## **Proposal for amendments to Draft new Regulation on uniform provisions concerning the approval of enhanced Child Restraint Systems used onboard of motor vehicles**

The text reproduced below was prepared by the expert from France, on behalf of the informal working group on Child Restraint Systems. It is based on ECE/TRANS/WP.29/GRSP/2011/15. The modifications to the current text of the new ECE on Child Restraint Systems are marked in bold or strikethrough characters.

Replace Figure 0 (d) by drawing below

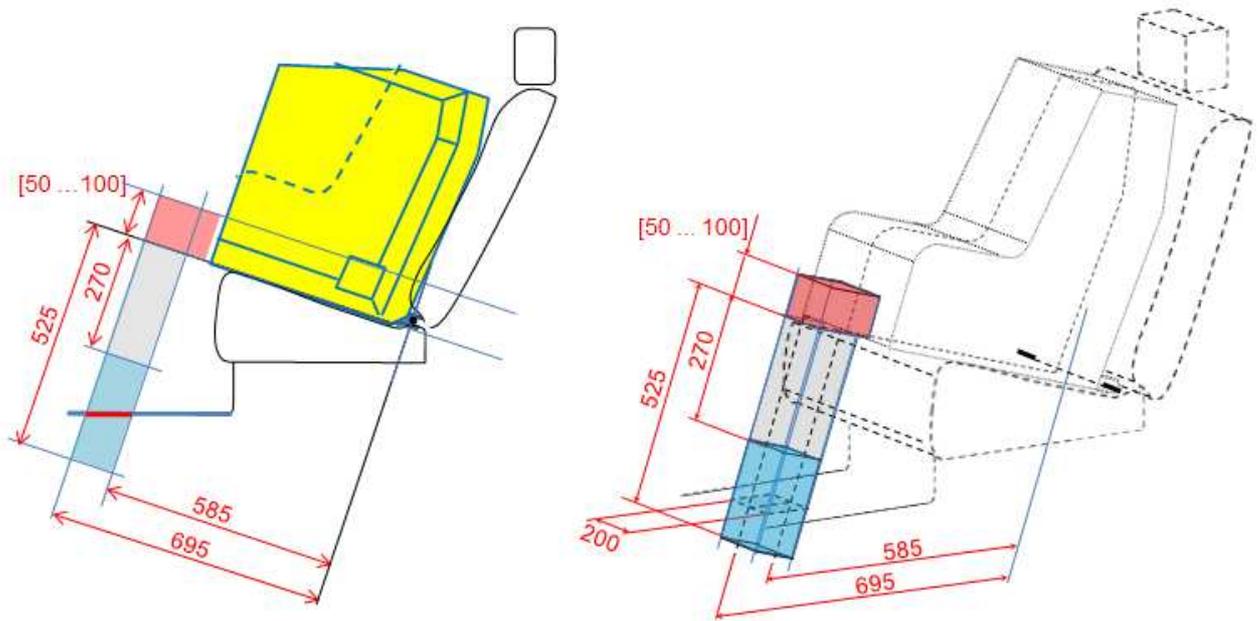
On paragraph 6.3.5.1., item (d) amend to read:

... [490] by **525mm** ...

On paragraph 6.3.5.1., item (g) amend to read:

... [620] by **585mm** ...

On paragraph 6.3.5.1. item (h), amend to read:  
... [820] by **695mm** ...

**Figure 5**

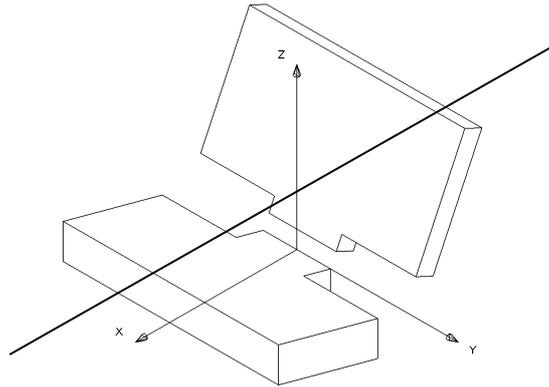
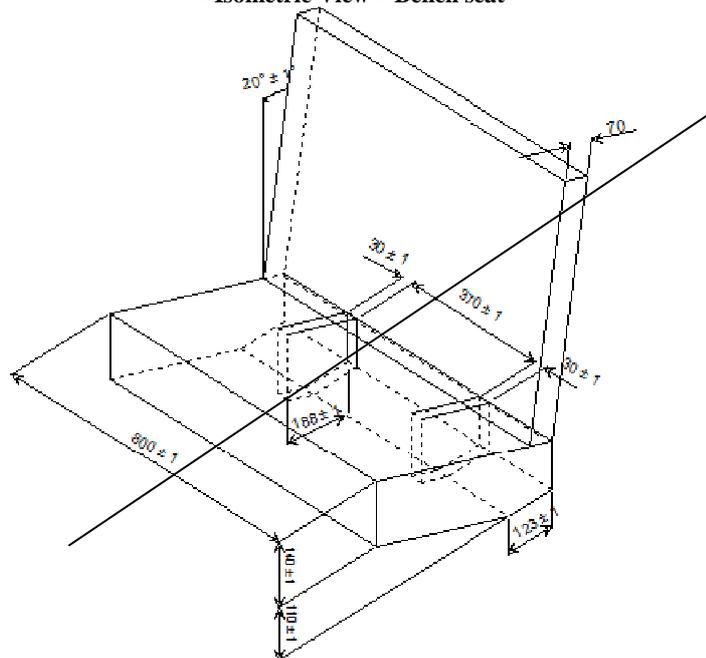
Delete the both drawings
